SUMNER-BONNEY LAKE SCHOOL DISTRICT SUMNER HIGH SCHOOL ADDITION - PHASE 2 VALUE ENGINEERING REPORT SEPTEMBER 12, 2025

Revised 10/13/2025 with updated Implementation Data

This value engineering (VE) report is presented to Sumner-Bonney Lake School District and the design team to support decision making at the design development phase for the Sumner High School Addition - Phase 2 project.

Baseline Concept

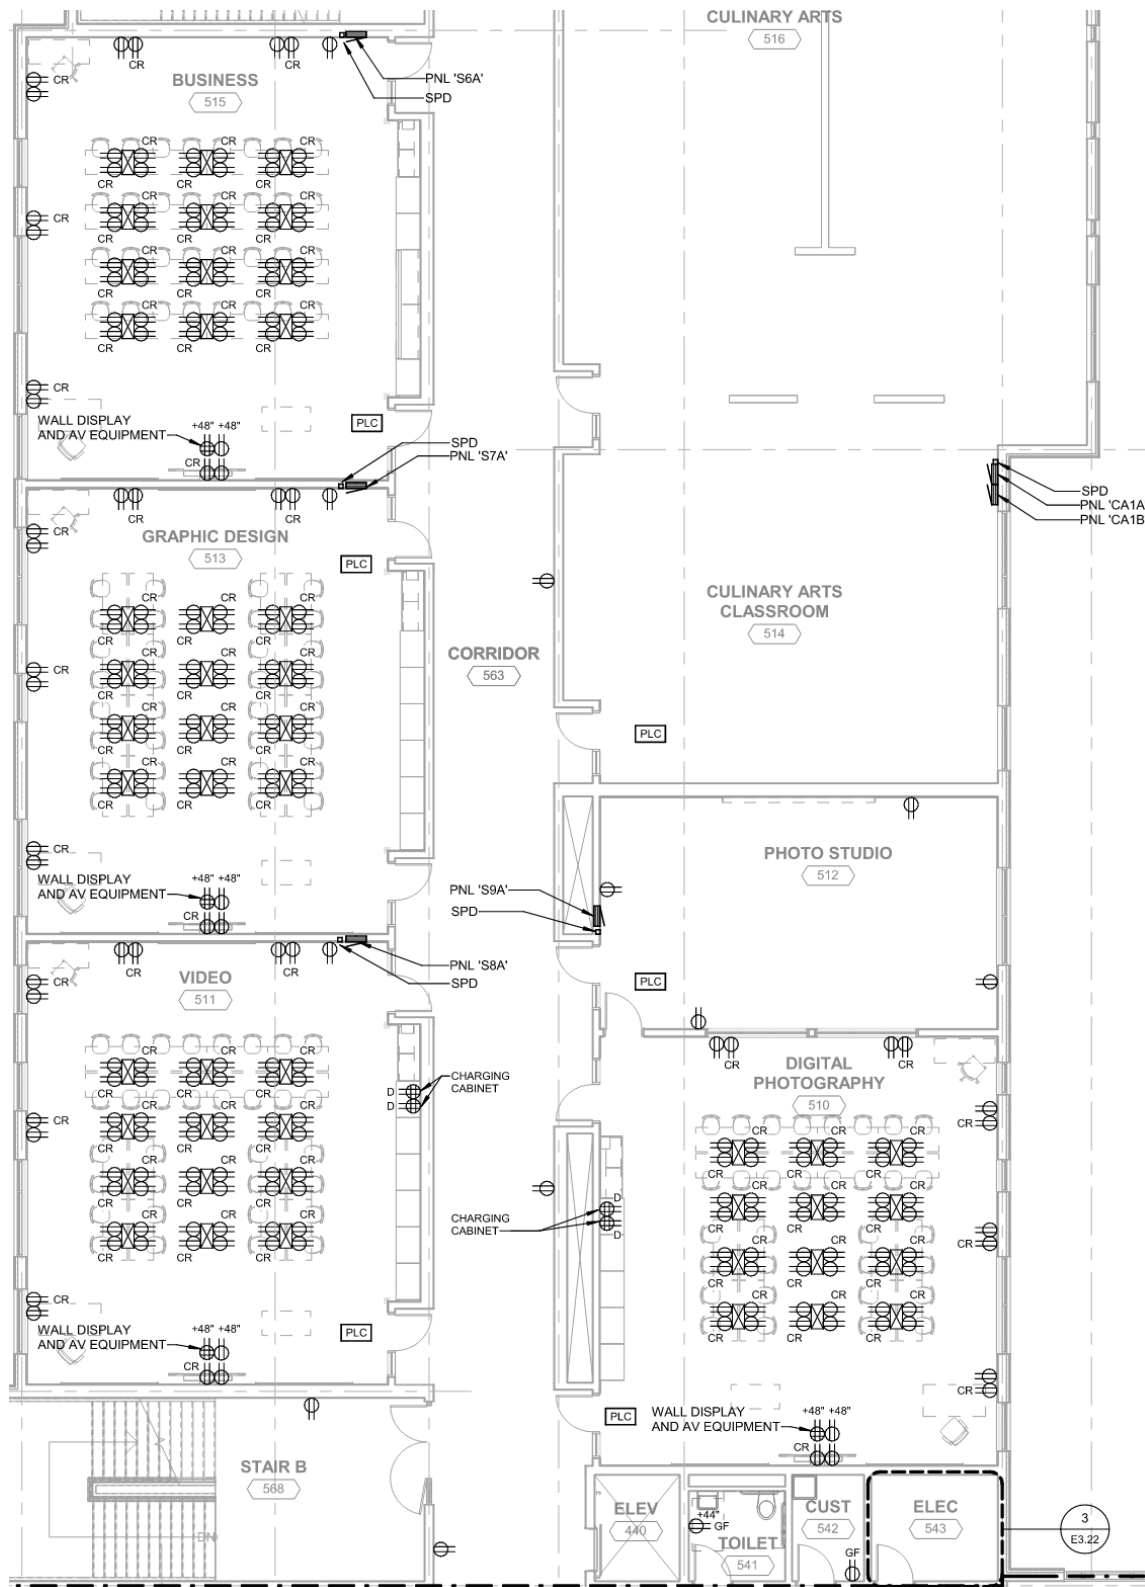
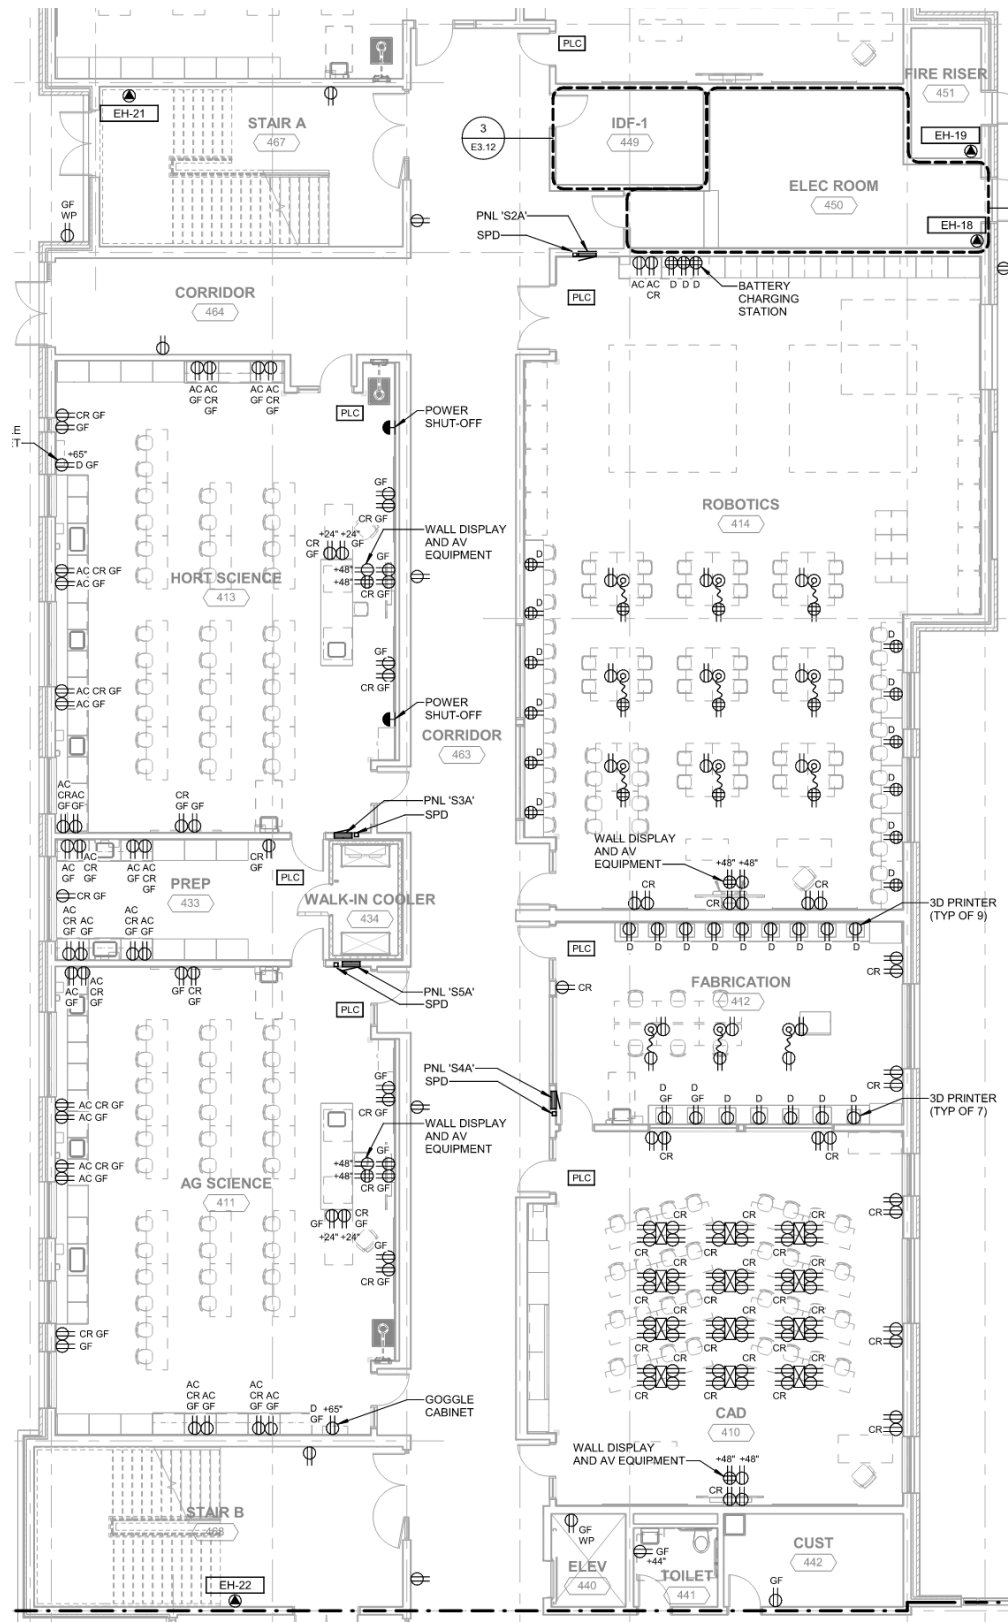
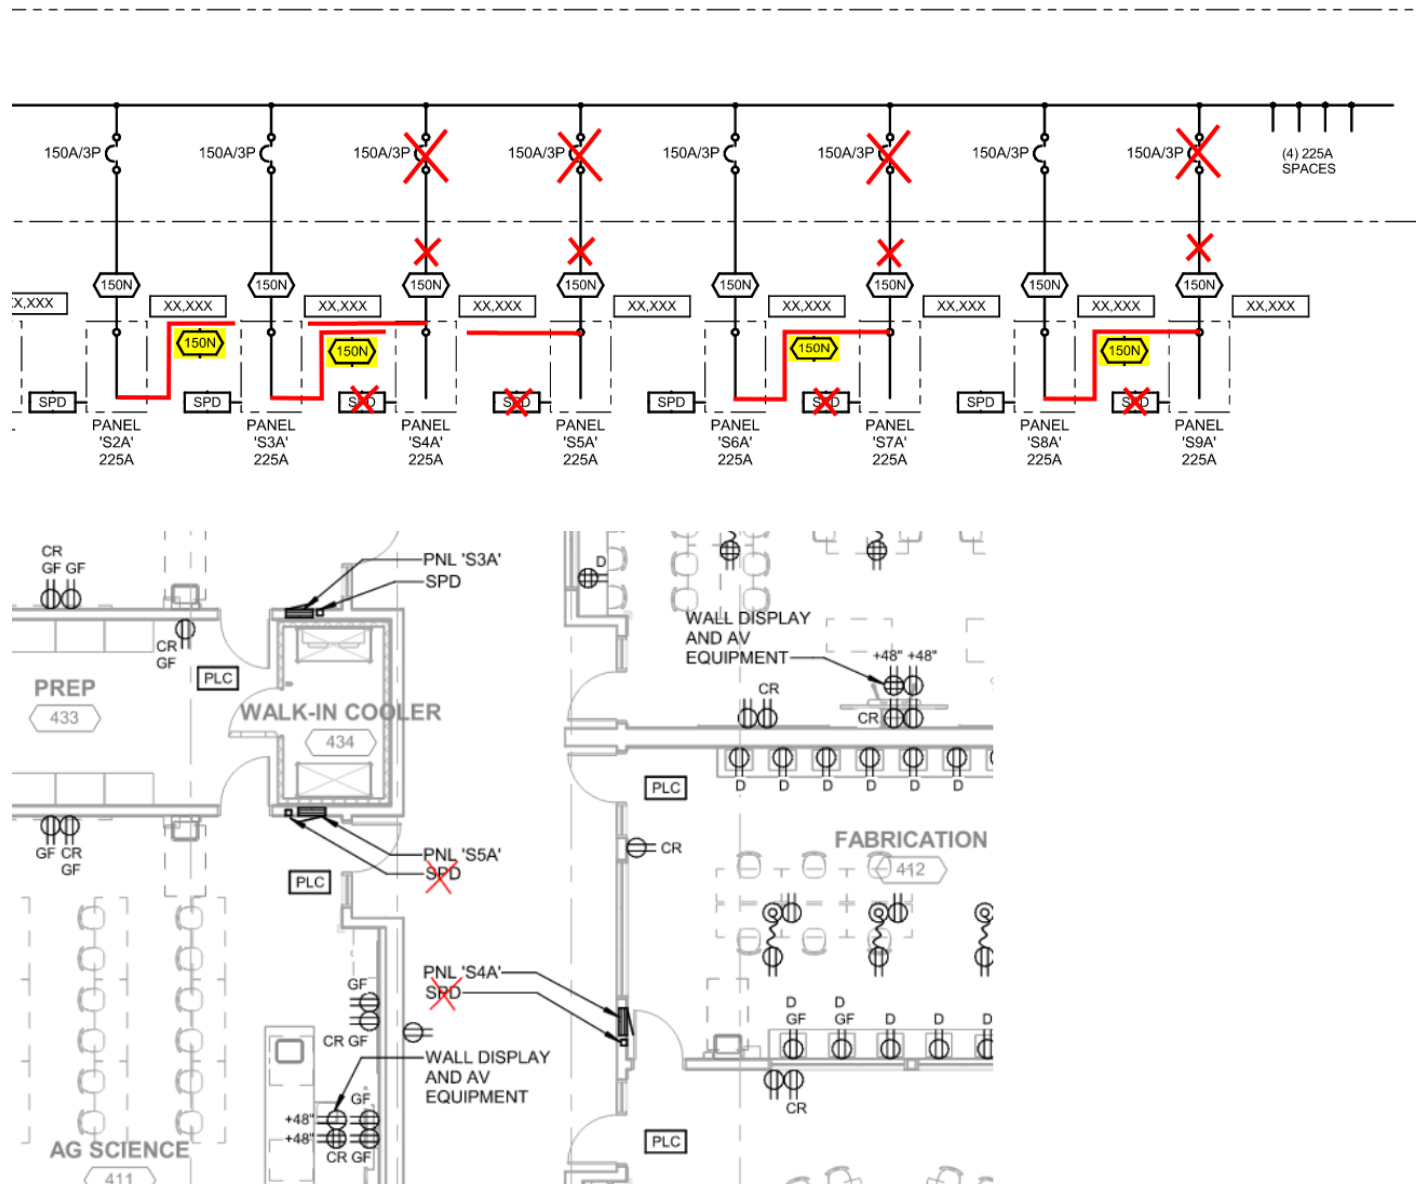
Dedicated power panels are provided in classrooms Robotics (Panel S2A), Hort Science (Panel S3A), Fabrication & Cadd (Panel S4A), AG Science (Panel S5A), Business (Panel S6A), Graphic Design (Panel S7A), Video (Panel S8A), Culinary Arts & Classroom (Panels CA1A & CA1B), and Photo Studio & Digital Photography (Panel S9A). Each panel has a dedicated feeder and circuit breaker connection at Sub Distribution Board SDB-2. Each panel also has a dedicated surge protector device (SPD).

- Feed Hort Science and AG Science panelboards panels from a single circuit breaker and feeder. Remove (1) SPD.
- Feed Robotics and Fabrication & Cadd panels from a single circuit breaker and feeder. Remove (1) SPD.
- Feed Business and Graphic Design panels from a single circuit breaker and feeder. Remove (1) SPD.
- Video (Panel S8A), and Photo Studio and Digital Photography (Panel S9A) are located near Electrical Room 543 and electrical room has room for panels.
